# PRODUCT CHANGE NOTIFICATION

### Bourns® Model CQ322522 and CQ453232 Series Non-shielded Power Inductors *Change to Plating Design*

IC23065

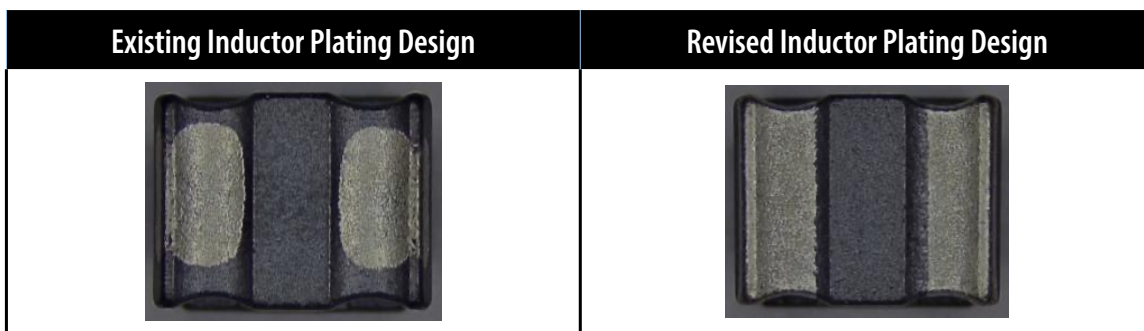
Riverside, California – July 18, 2023 – As part of our continuous improvement efforts, effective July 24, 2023, Bourns will change the plating design for the Model CQ322522 and CQ453232 Series Non-shielded Power Inductors. The modified plating design will have full coverage to improve the solderability of the component. A list of affected part numbers is included below.

The form of the affected inductors will change slightly due to the plating design change. The fit, function, and specifications of the affected part numbers will remain the same. The quality and reliability of the affected inductors should be improved as a result of the design change. Traceability will be maintained through lot code and date code.
